APS KNIT COMPOSITE LTD.

31st October 2015

Observations

Stress Level of Columns (In Case of 9-storey Building)

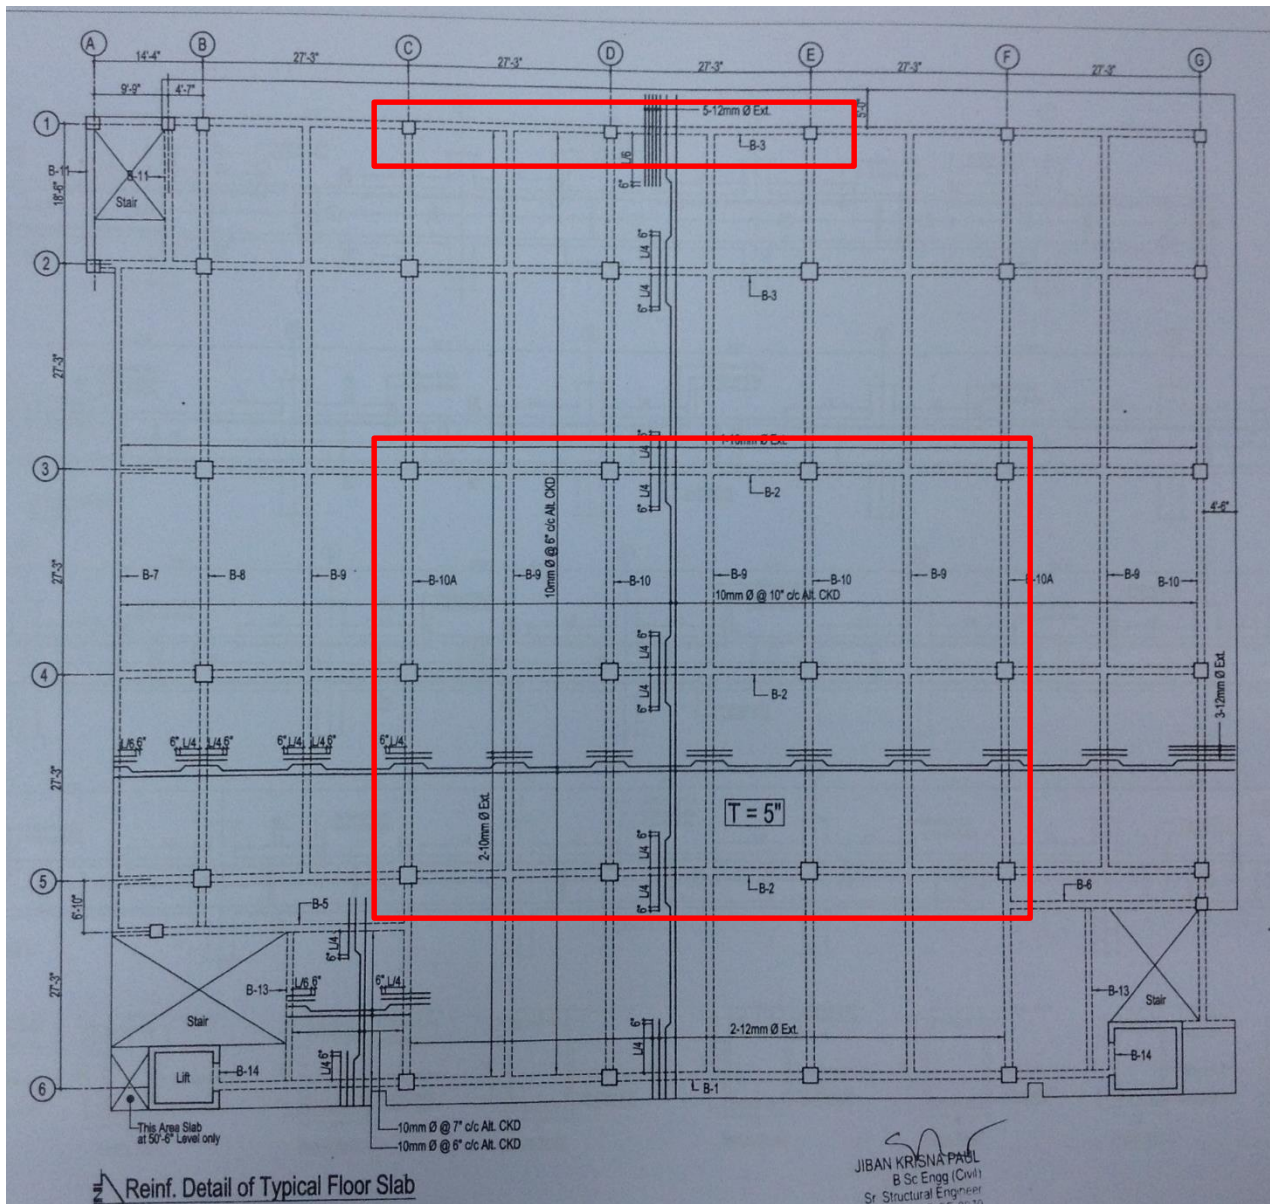
Columns at marked areas have high stress level in case of final state (9-storey)

Item No.	Observation	Recommended Action Plan	Recommended Timeline
1	Stress Level in Columns	At the current state of the building, stress level at columns is low however when the 9-storey building (final stage) was checked it was found to be high. Verification of concrete strength should be made by core sample tests before proceeding with the construction.	6-months
2	Stress Level in Columns	Make structural alterations if required as advised by Engineer.	6-months
3	Hairline Cracks at First Floor Slab	The First Floor is used as a storage area and cracks observed at the bottom face of the slab, most probably due to excessive loading. The cracks should be monitored and the loading should be limited with the advise of the Building Engineer.	6-weeks
4	Hairline Cracks at First Floor Slab	Loading plan should be prepared by the Building Engineer for the storage areas.	6-weeks
5	Hairline Cracks at First Floor Slab	Necessary structural alterations should be done based on the outcome of the investigations.	6-months

Cracks at First Floor Slab

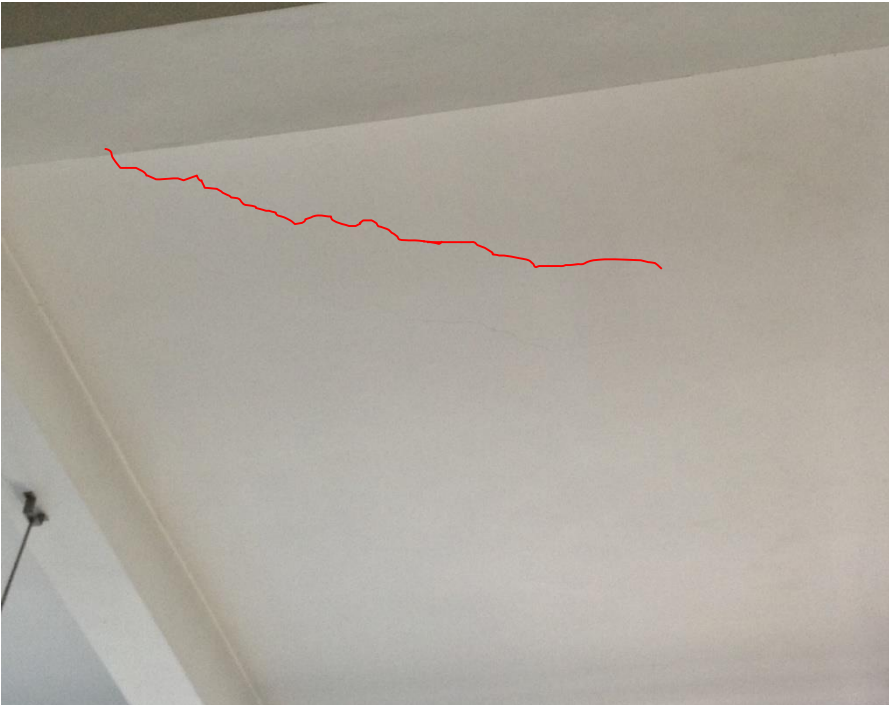
Hairline cracks observed at the bottom part of the first floor slab on which heavy loads are being applied due to stored materials.

Discrepancies between Permit Drawings and Observations

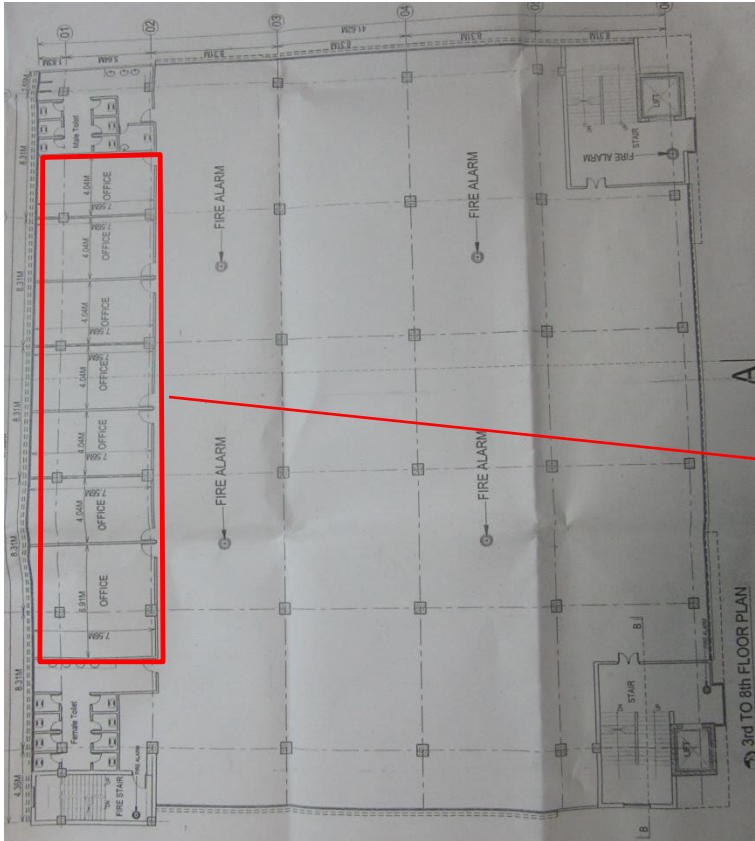
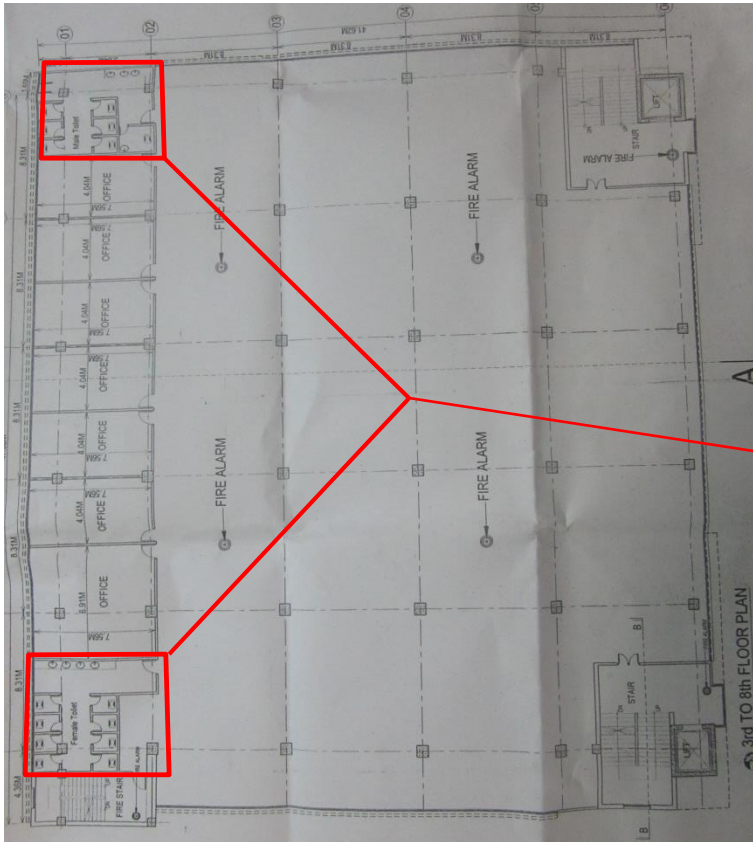
On 5th floor there was a large toilet area instead of office room on West end of building which was not present on permit drawing.

On 1st to 4th floors at the West en of the building, there were bigger toilet areas of 11 cubicles instead of 8 cubicles shown on permit drawings.
